Product/Process Change Notice (PCN)

File Number #: ConUSB_20150512

Product Affected: 61400416121

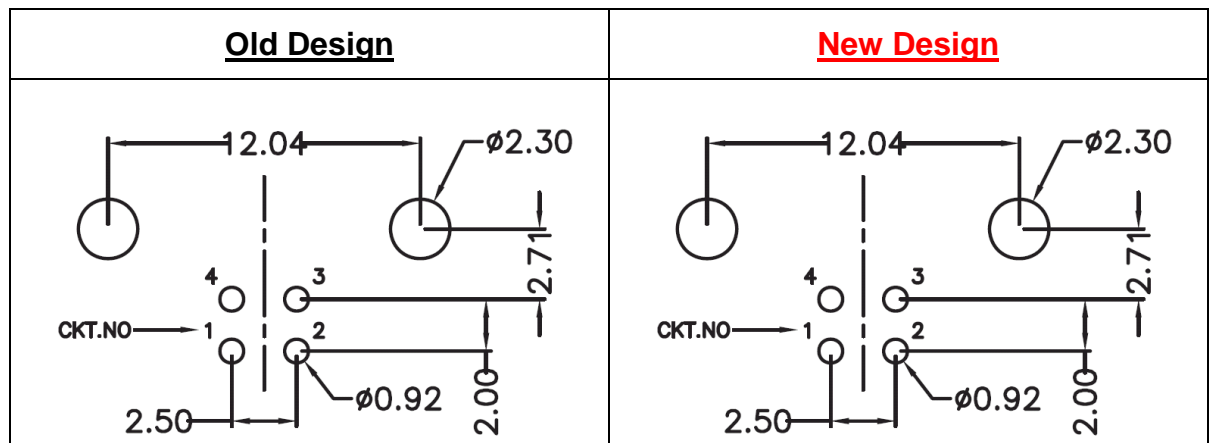
In order to enhance the product reliability, the production method will be changed and fully automated quality controlling machines will be implemented.

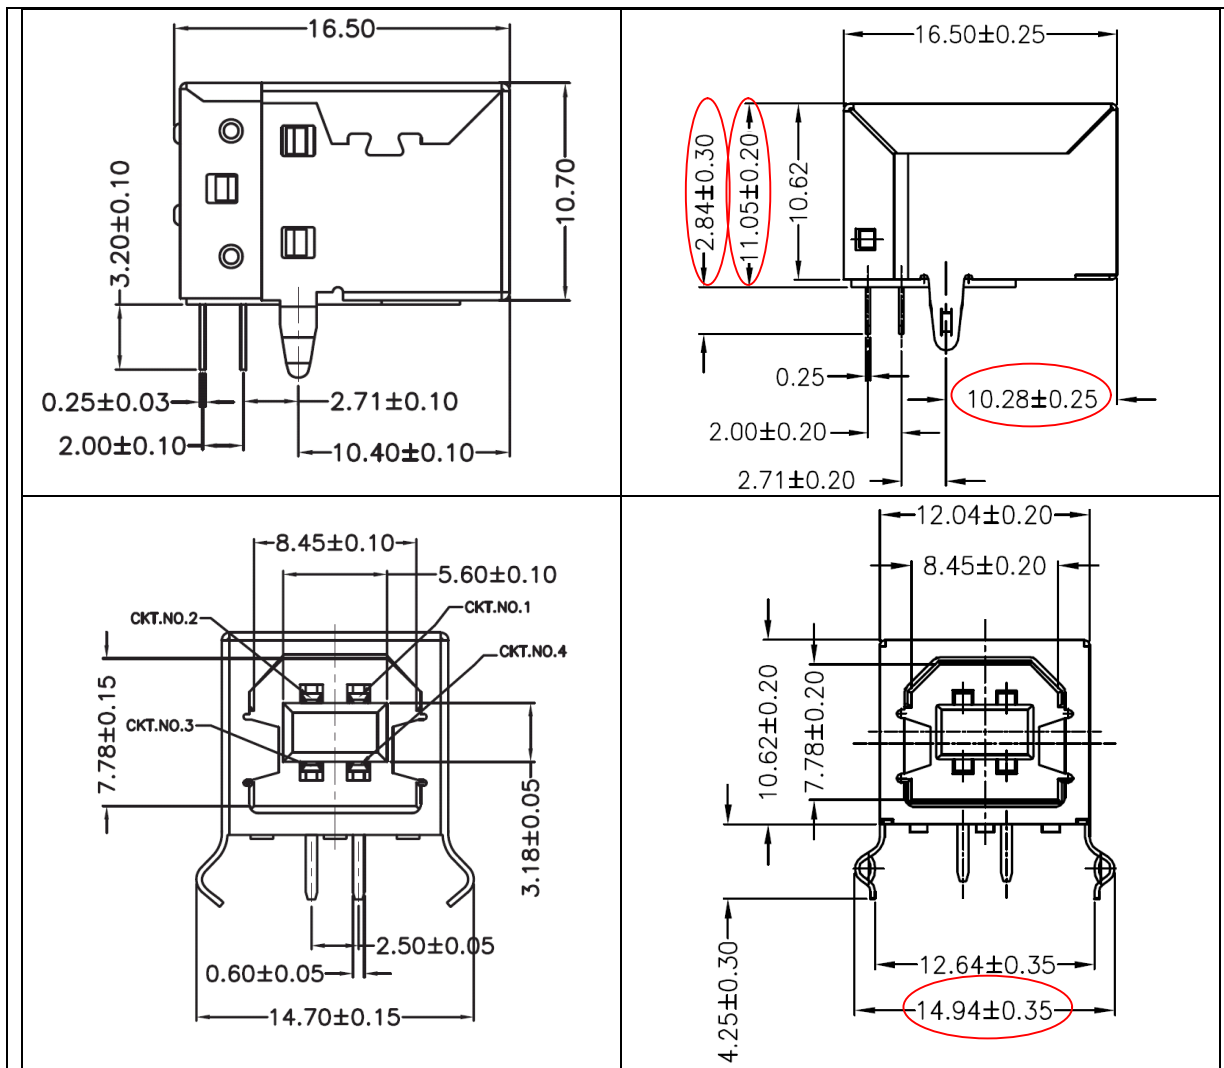
There are design changes but the layout, electrical and mechanical properties remain the same.

A fully automatized process will be implemented and CCD inspection controls will be added. The design changes are summarized below and marked in red:
